Power Section

Battery Charging Section

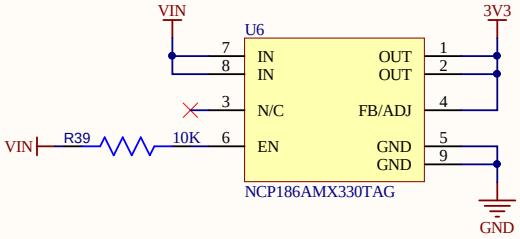
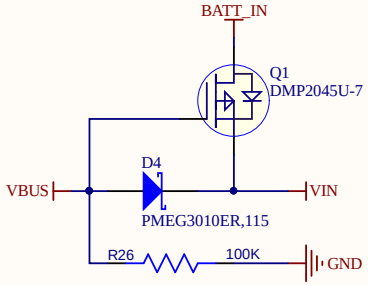
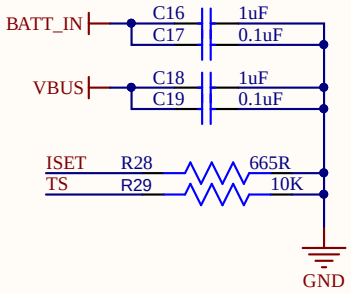
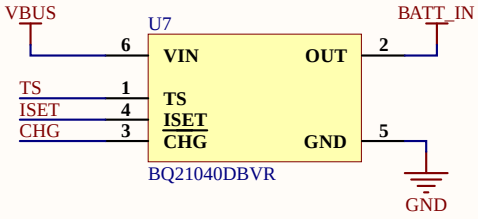
Place Decoupling Capacitor with there respective pins.

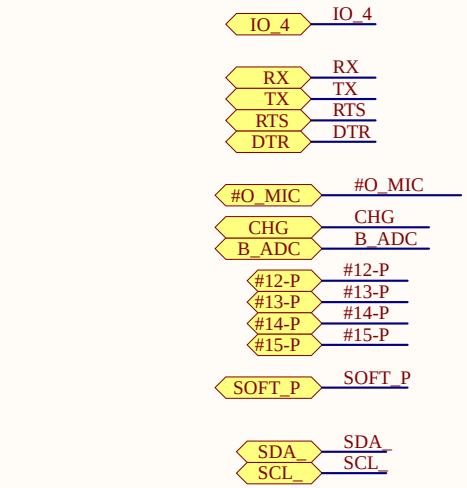
ISET Resistor Value is changed in Parameters, please be careful.

As per Datasheet, the value should not exceed 675 Ohm.

External Enable wouldn't be used as Development board already had circuit.

Controller Section

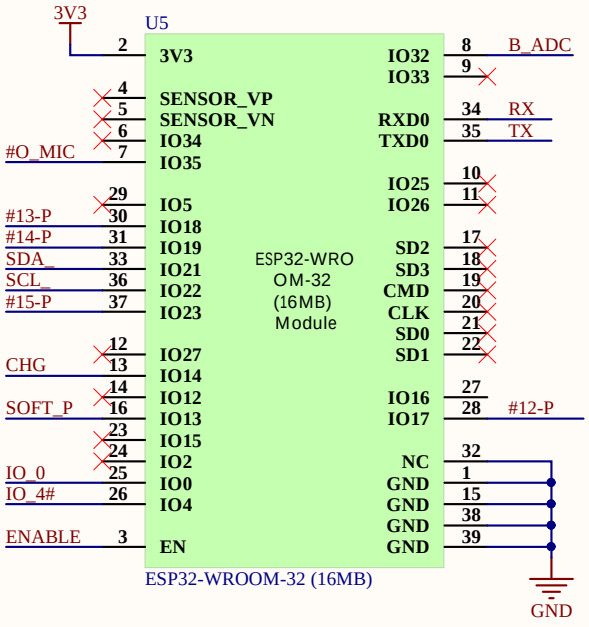
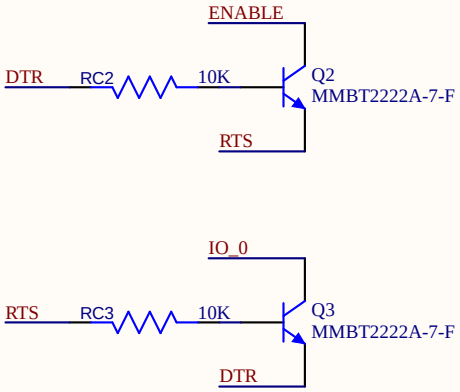
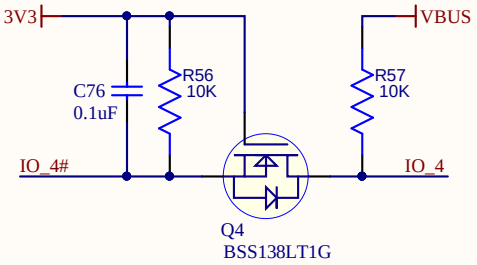
SW2 is being used for Software Reset.

Connector Section

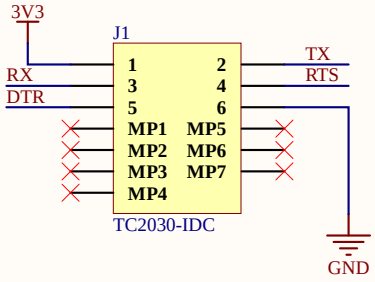
Mentioned Capacitors will be placed with Battery Connector and with USB Main Connector.

No Need to place Decoupling Capacitors with Switch as this is just path.
